**From:** Beggs, Tauren R - DNR  
**Sent:** Monday, November 3, 2014 9:57 AM  
**To:** 'James McDonald'  
**Cc:** mlove@bayenvironmental.com; Scott Ahl; Greg Buckley;  
nmvorsch@bayenvironmental.com  
**Subject:** RE: Eggers West Plant  
**Attachments:** 20141103095055082.pdf

Thank you for the plan sheets. There are two separate issues I want to address for this project: 1) residual contaminated soil and 2) removal and replacement of the cap.

**From:** James McDonald <jammcd@two-rivers.org>  
**Sent:** Friday, October 31, 2014 4:25 PM  
**To:** Beggs, Tauren R - DNR  
**Cc:** mlove@bayenvironmental.com; Scott Ahl; Greg Buckley; nmvorsch@bayenvironmental.com  
**Subject:** Re: Eggers West Plant  
**Attachments:** 20\_Plans.pdf

14th STREET RW, BRRTS #02-36-519548  
SOIL ANALYTICAL RESULTS  
AND LATERAL EXTENT OF CONTAMINATION

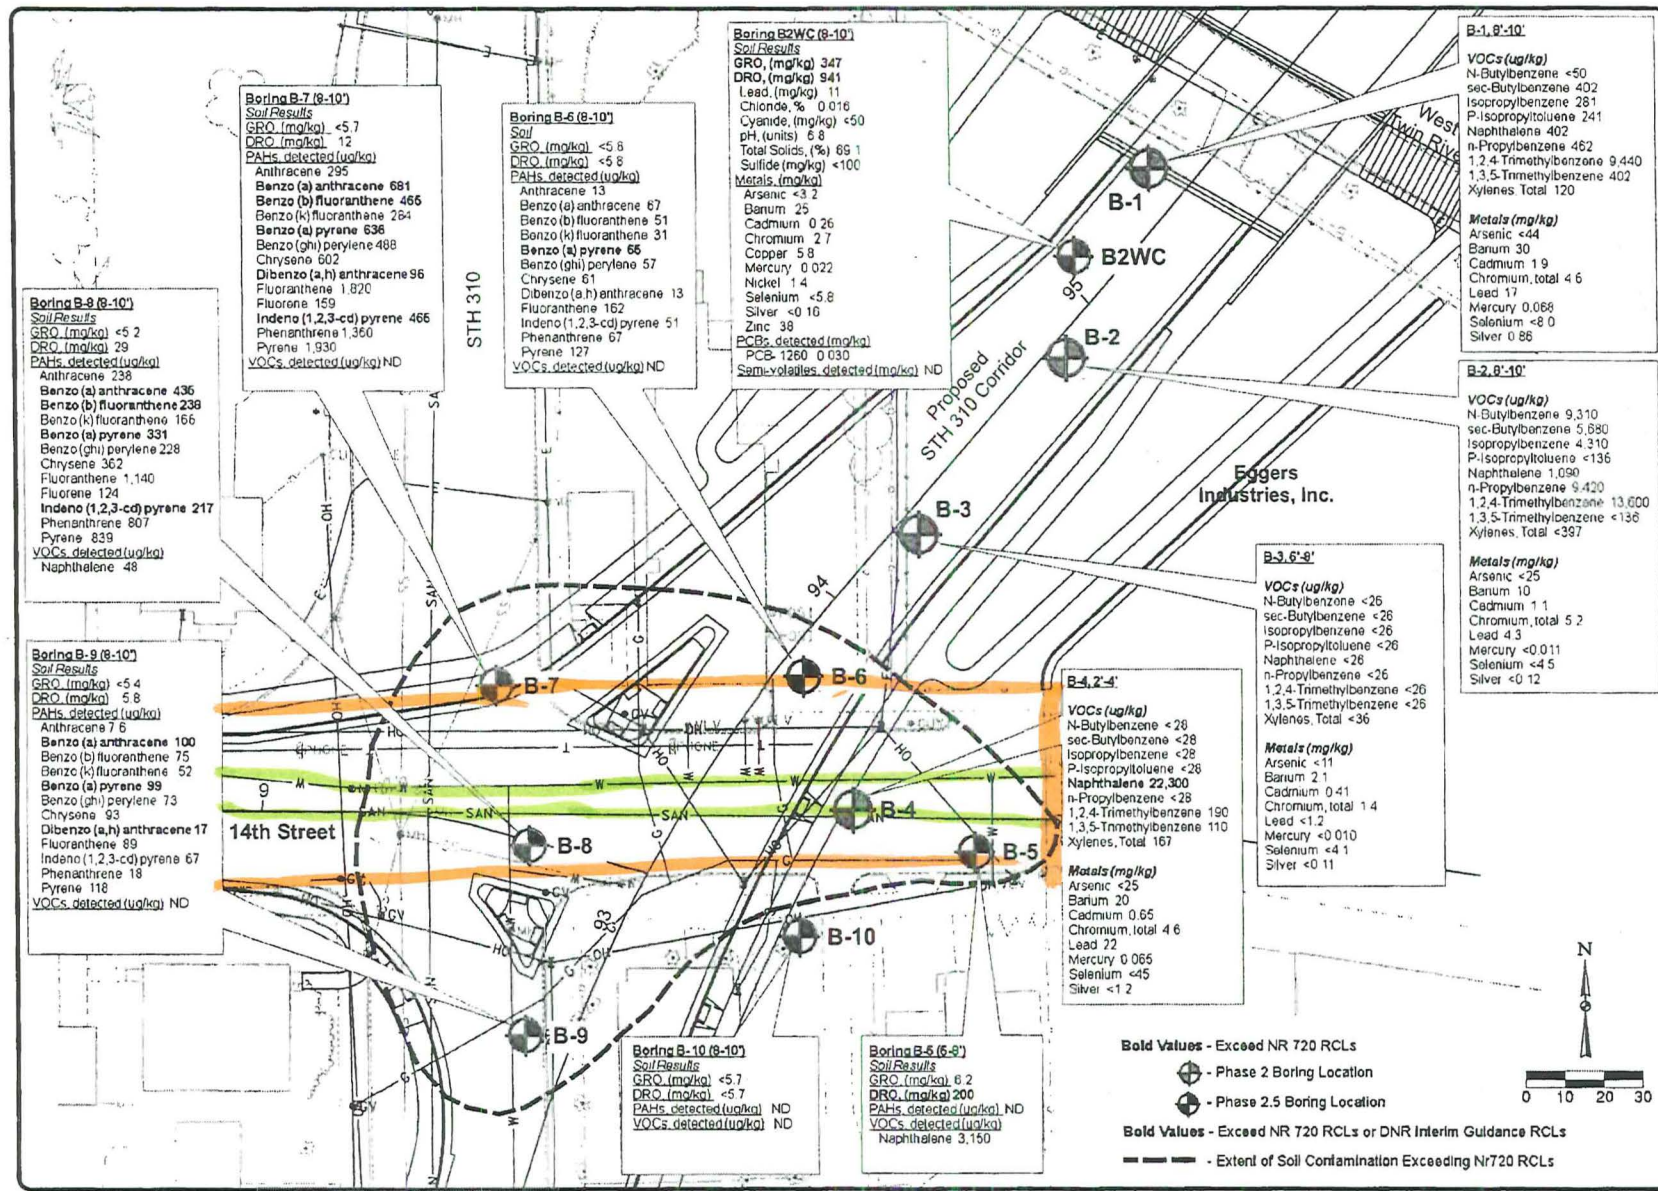
- 1) Based on the attached map from the closed BRRTS case, 14<sup>th</sup> St ROW – WI DOT, BRRTS # 02-36-519548 and the plan sheet you provided, it appears the extent of PAH contaminated soil is between 62+00 and 64+00 of your project limits. I highlighted the area on the attached map that relates to your current project. Since manhole SA7 has been placed, you should be at the end of the contaminated soil extent. For this project, the contaminated soil being reused for backfill is acceptable. If any contaminated soil was not used for backfill, it should have been properly handled and disposed at a licensed landfill. If any of the contaminated soil was placed at another site, it must be recovered and properly handled and disposed. If you discover any more contamination during the utility replacement that is not associated with these closed cases, please notify me. **Please submit any pertinent final documentation to me that explains what was completed once the project is finished, so I can use that information to determine if an update to the GIS Registry is needed for the 14<sup>th</sup> St ROW – WI DOT closed case.**

SITE MAP

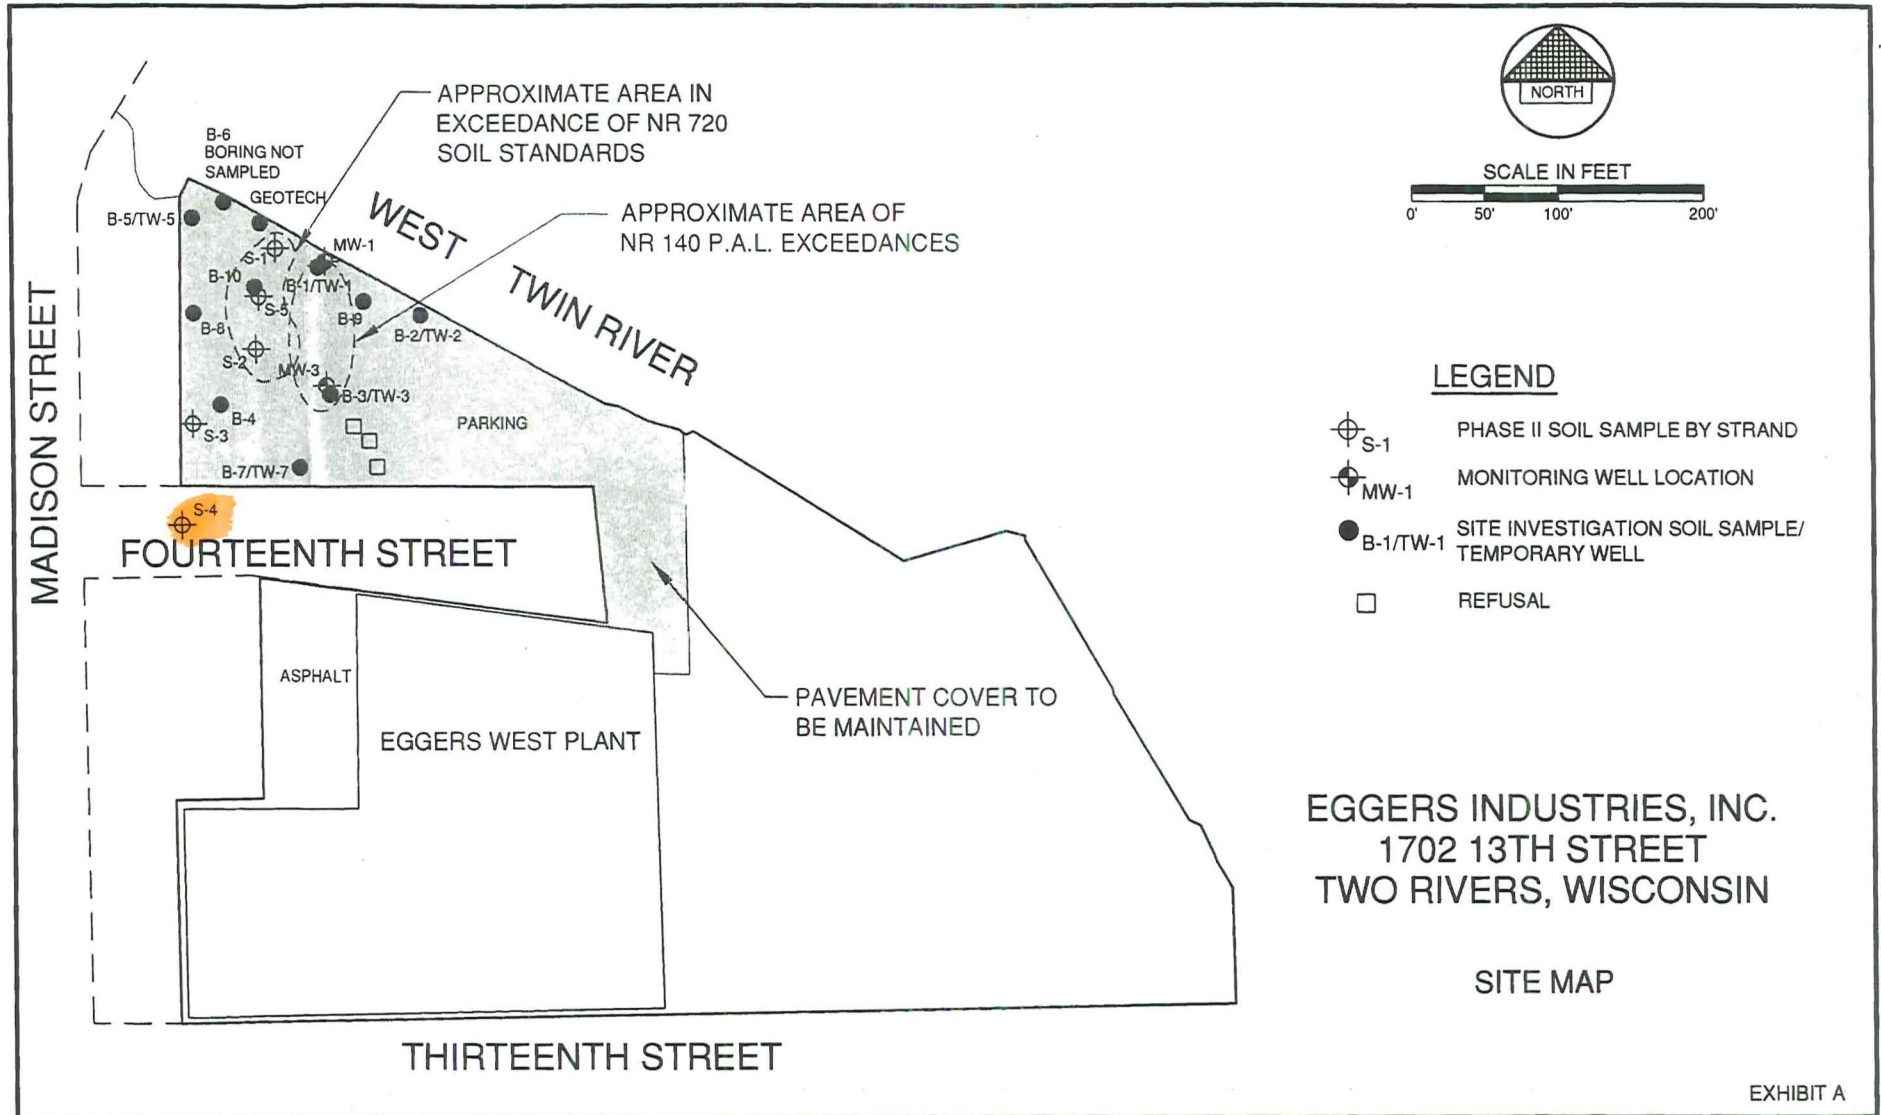
- 2) This project goes through part of a cap that is required to be maintained as a continuing obligation of the closed case Eggers Industries West Plt – WI DOT, BRRTS # 02-36-521430 (please see attached map for the shaded cap area). Notification to the DNR and approval is required prior modifying or removing a cap. I will accept your previous email as notification to the DNR and this email will act as your approval to proceed. Since you will be replacing/or have already replaced the current pavement cap with an equally impervious or more impervious cap, this will be acceptable; however, **you are required to submit a Continuing Obligations Inspection and Maintenance Log (Form 4400-305), so it can be added as an update to the GIS Registry. On the log you will need to explain what changes you made to the cap. Also, take photos of the original capped area & the portion of the cap that you modified and attach the photos to the log.** This log can be submitted by email; the link to the log is <http://dnr.wi.gov/files/PDF/forms/4400/4400-305.pdf>.

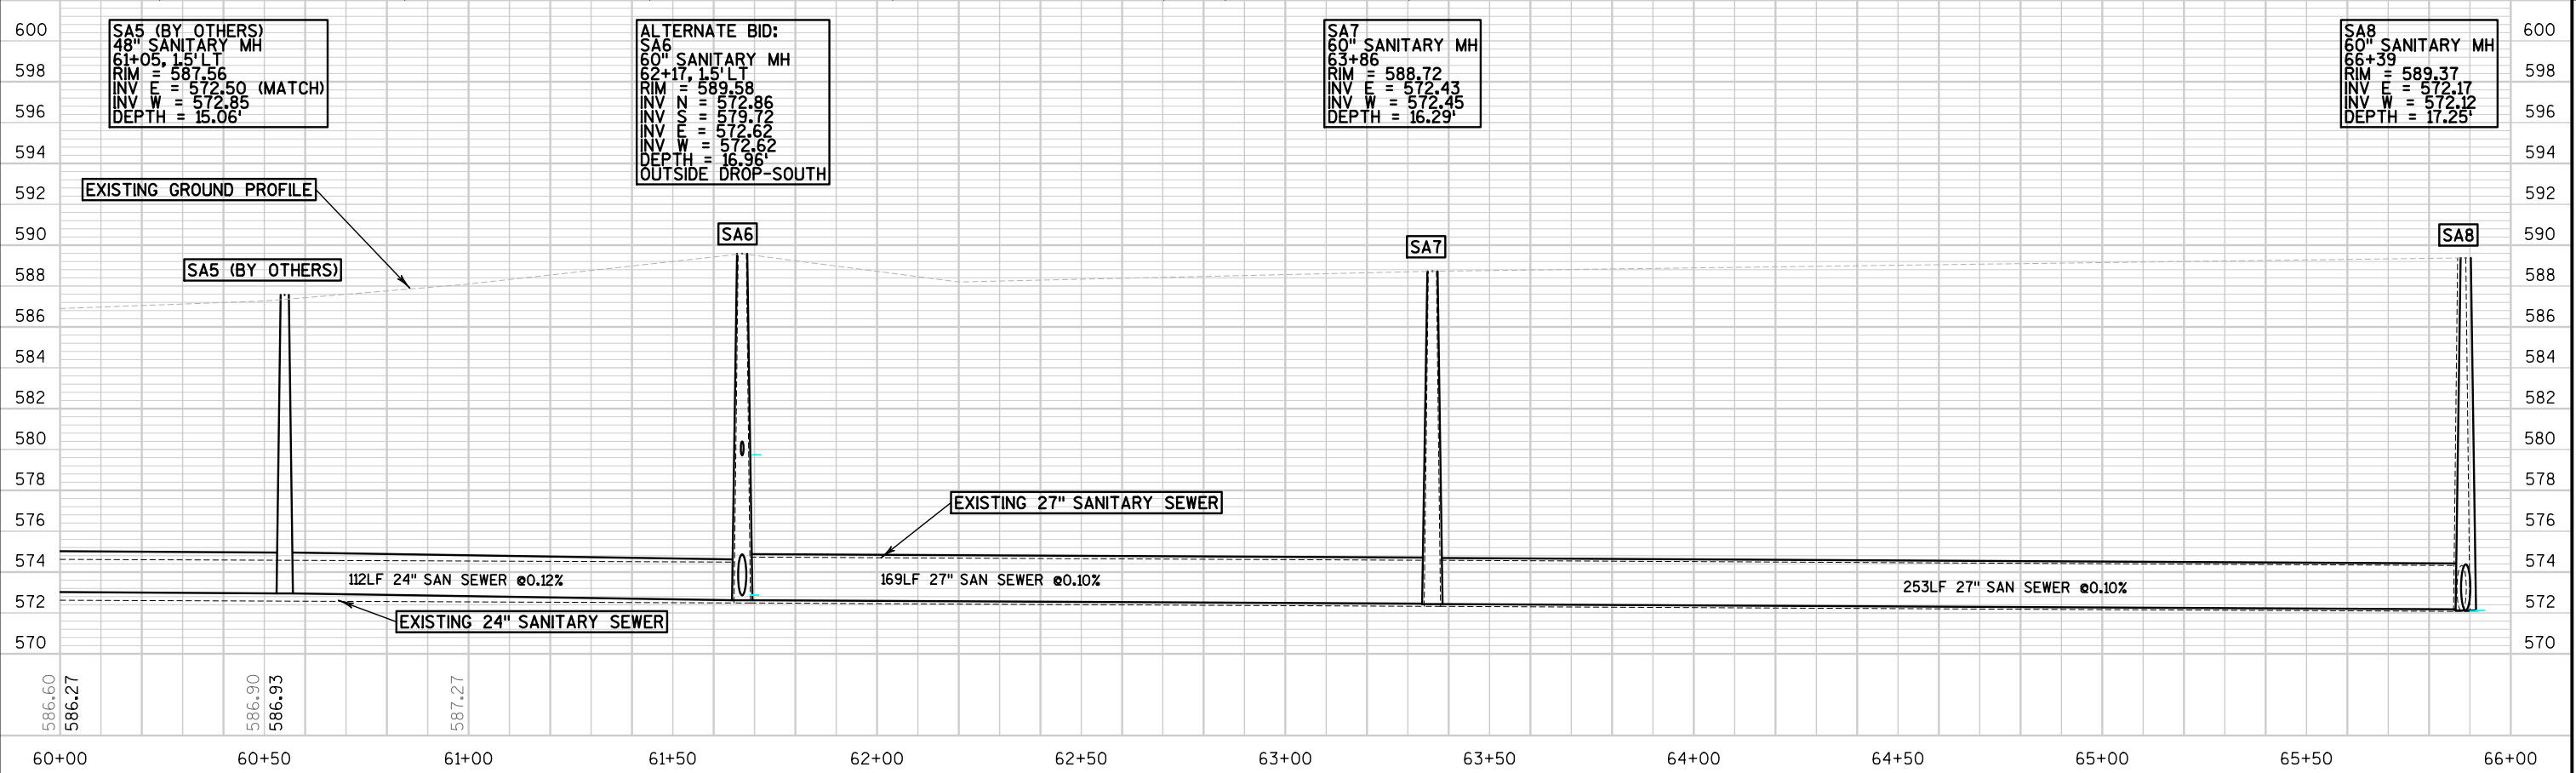
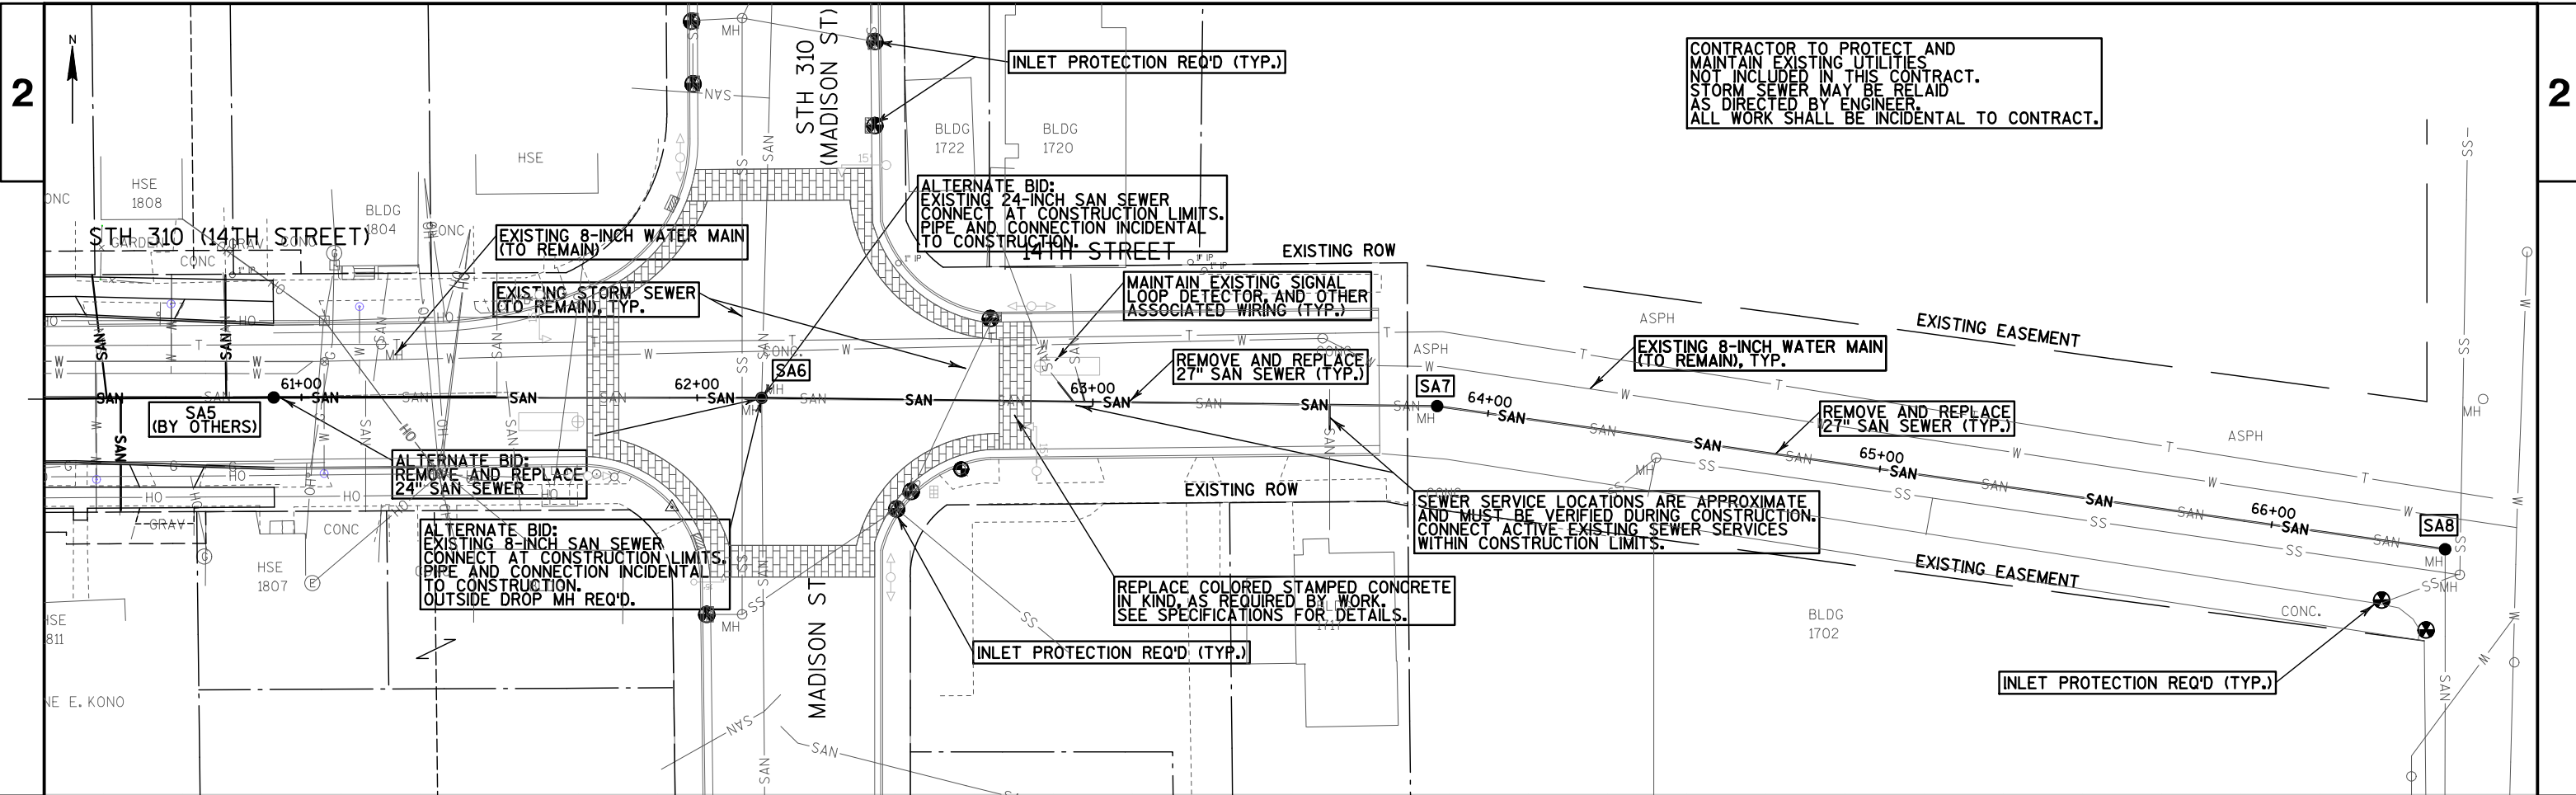
Attached should be a plan set for the Sanitary Sewer relay. Note that the phone conduit is atop the water main on the east end of the project. I believe that manhole SA7 has been placed.

Attached, you should find the information that was sent to me by Mark Love, PSS, with Bay Environmental Strategies. As mentioned, we did place about `50 feet of sanitary main to date, most of which has been paved with concrete. Although a bit difficult to tell from the drawings, it appears we may have already paved over the location of boring S-4.
